BLOCK 345 - ELEVATION 3

- ☐ REVIEWED
☒ REVIEWED AS NOTED
☐ REVISE AND RESUBMIT

PRATT HEIGHTS

project name: **LECCO RIDGE DEV. INC.**

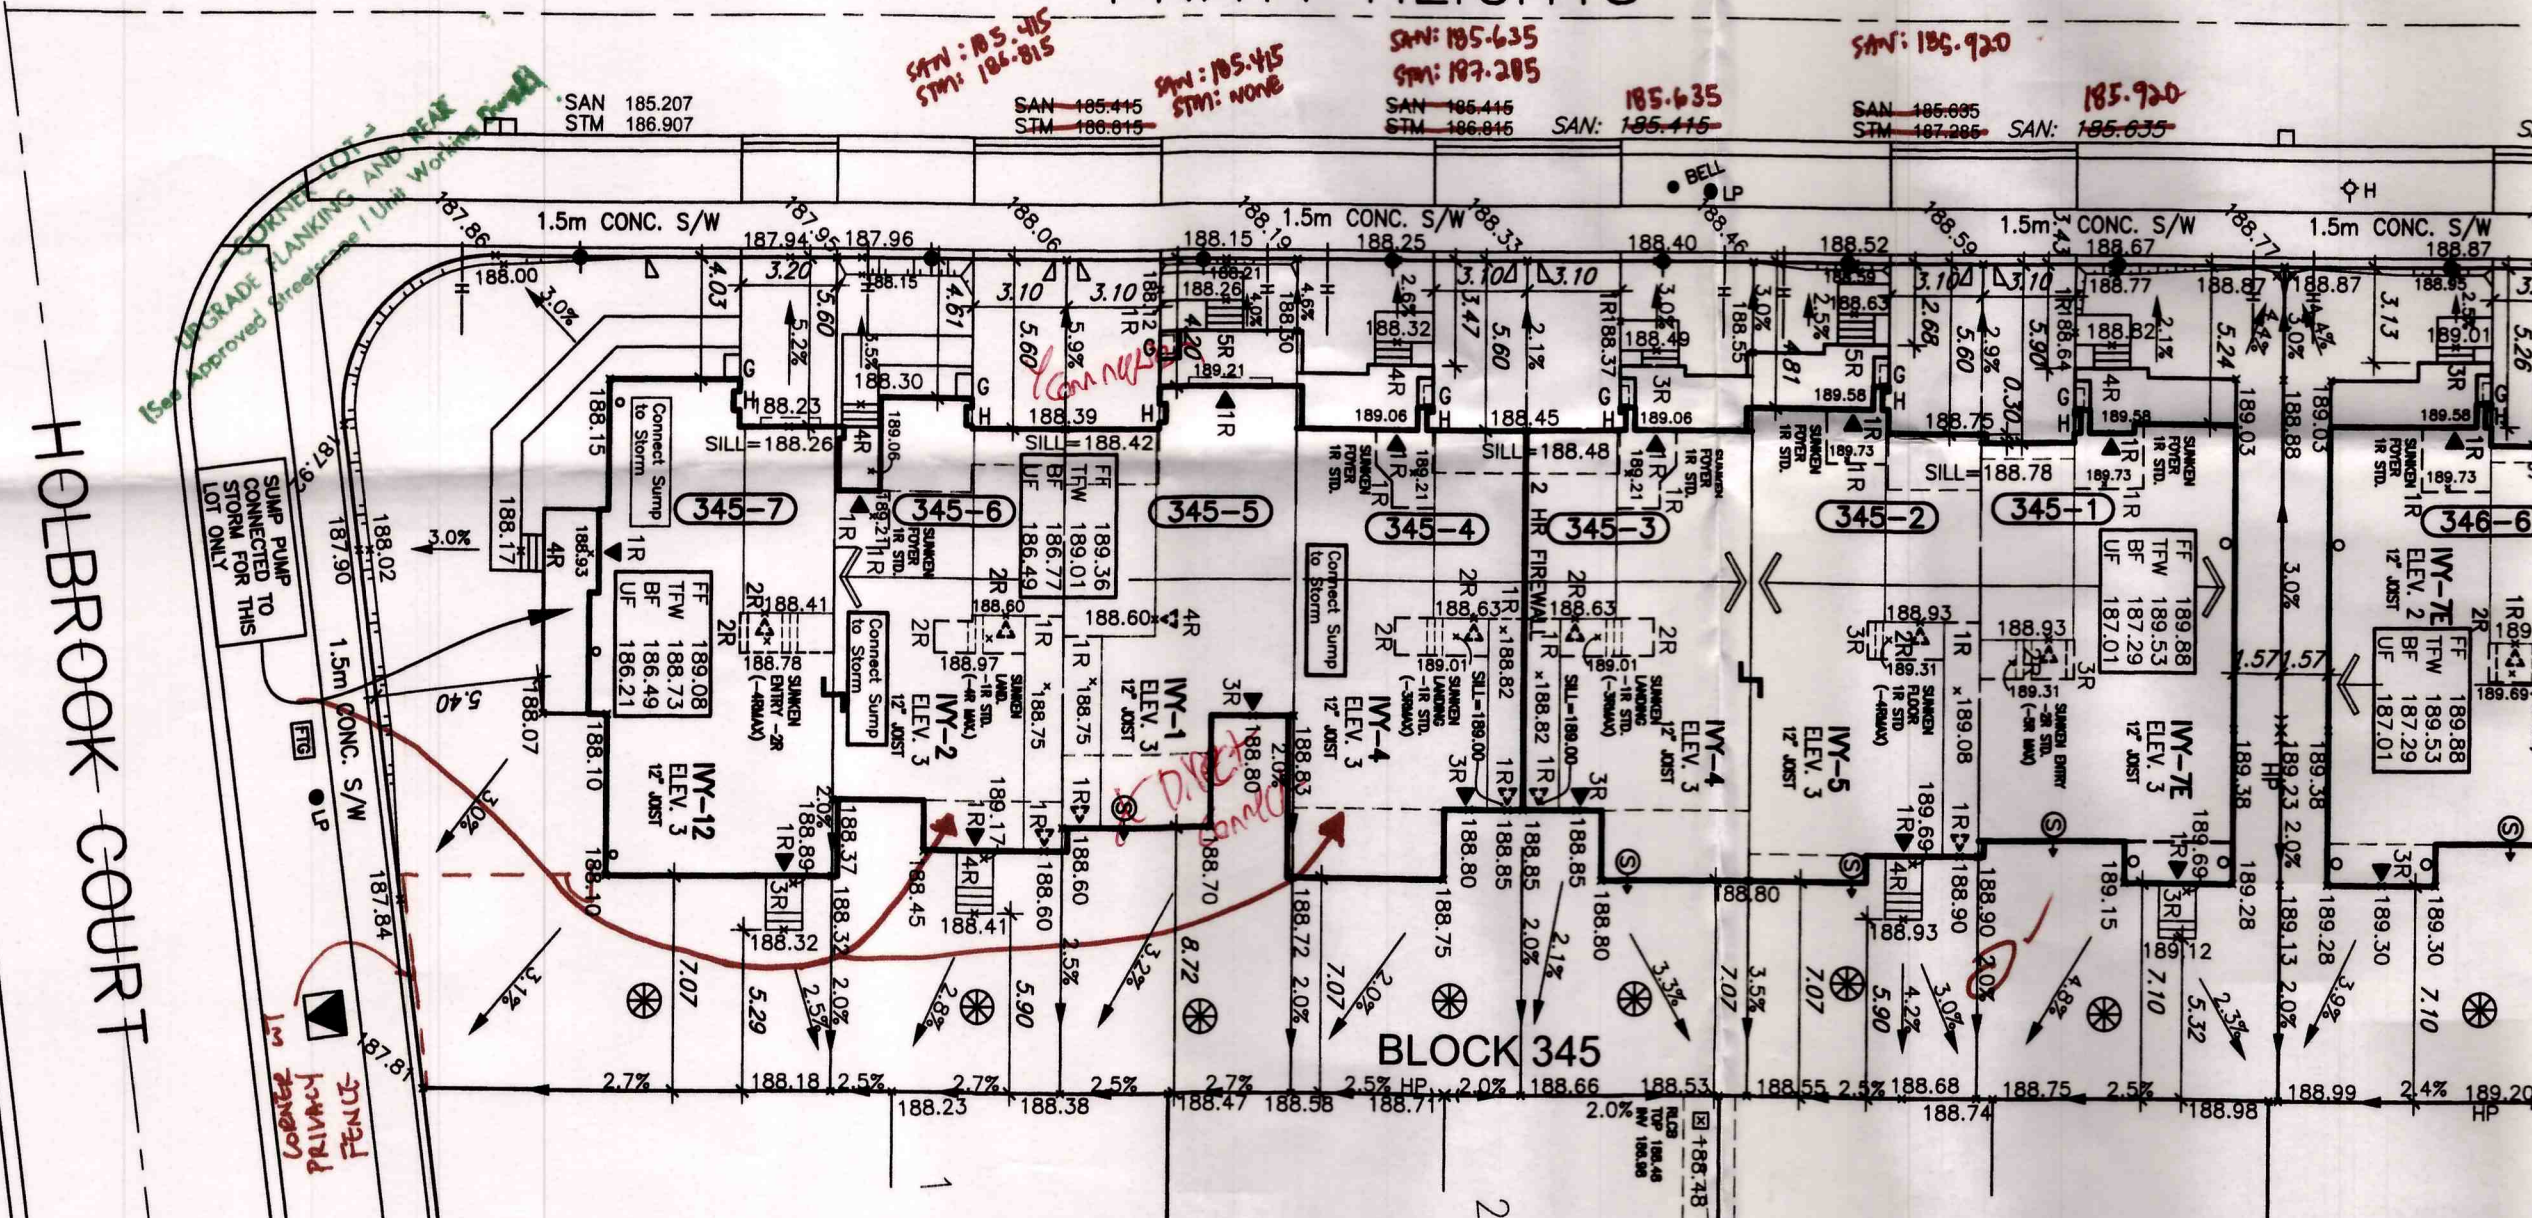
UNIT 5 to have direct connection via y connection with unit 6 as per green park correspondence may 5 2017
